City of Santa Barbara
California

PLANNING COMMISSION
STAFF REPORT

REPORT DATE:	October 5, 2007
AGENDA DATE:	October 11, 2007
PROJECT ADDRESS:	1727 Santa Barbara Street (MST2006-00529)
TO:	Planning Commission
FROM:	Planning Division, (805) 564-5470 Jan Hubbell, AICP, Senior Planner JH for JH Jaime Limon, Senior Planner JL

EAST ELEVATION 1/4" = 1'-0"

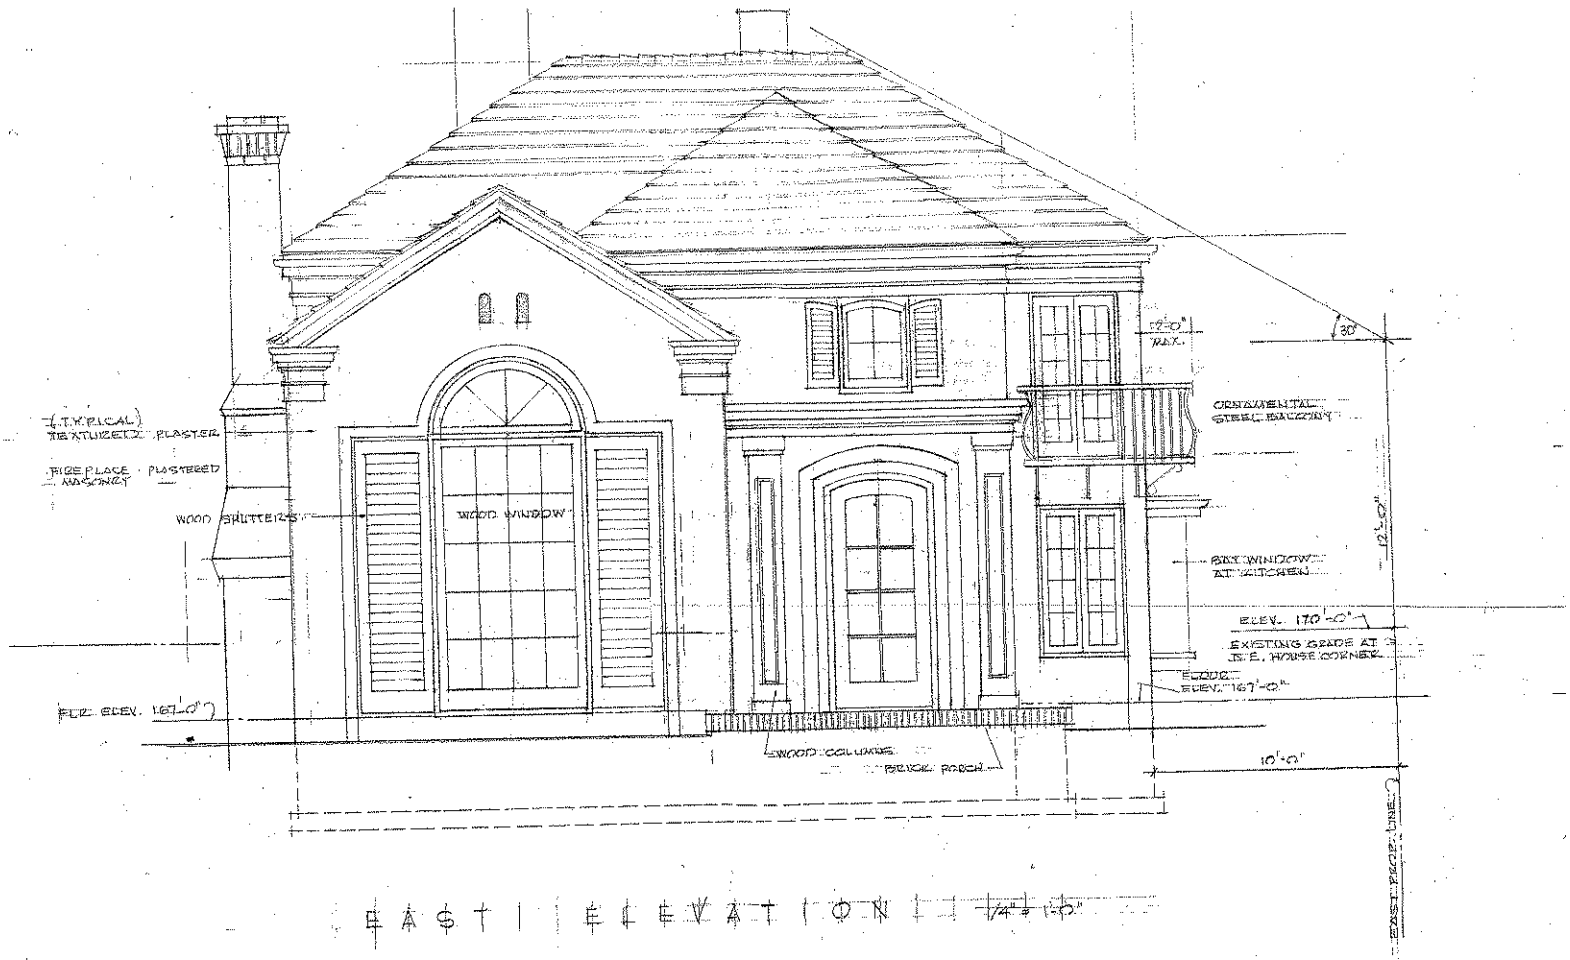
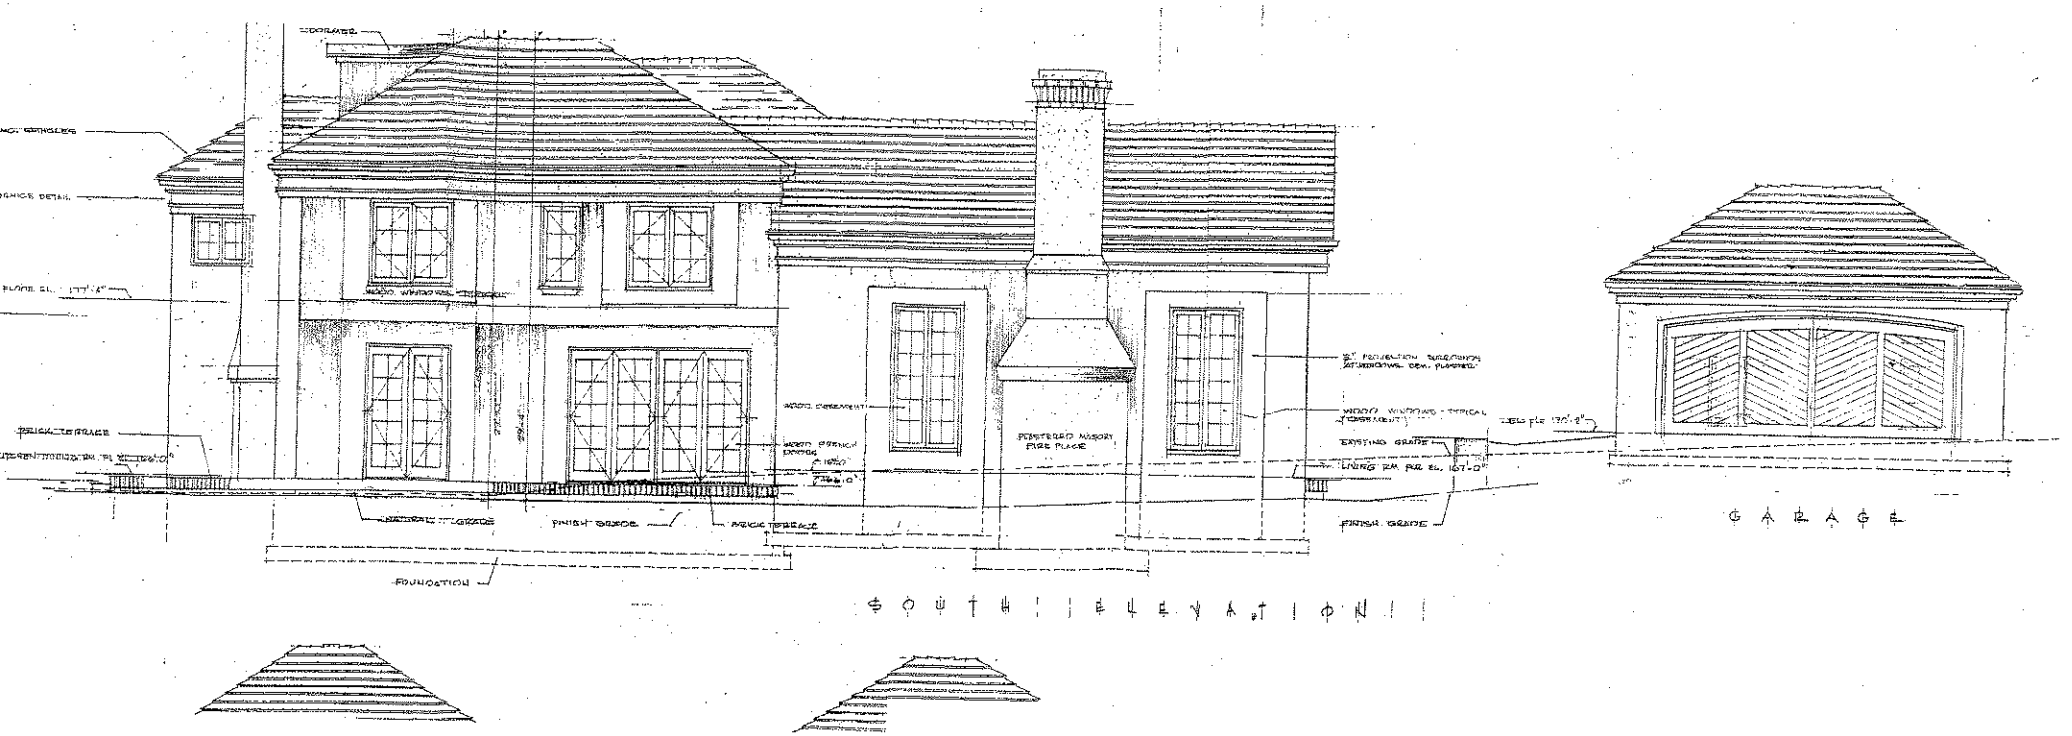
2) Removal of the Palm tree is acceptable, recycle if possible.
3) The proposed roof is too high, lower to 25 feet maximum height.
4) Restudy the proportions of classical/traditional elements on the house to be more in human scale with the architecture.

8) Verify the actual floor area ratios for consistency.
9) Redesign the roof to be a less than 5 foot attic or include that square footage in the floor area calculation.

1) The 29 feet, 6 inch roof height is acceptable; the Board understands the attic space will not be habitable.
2) The height achieved in the design is compatible with the existing neighborhood design because the structure is located in a historical neighborhood and the house is of a historical design. In this instance the design is superior to a lower roof.
3) The applicant is to provide three sets of drawings when returning.
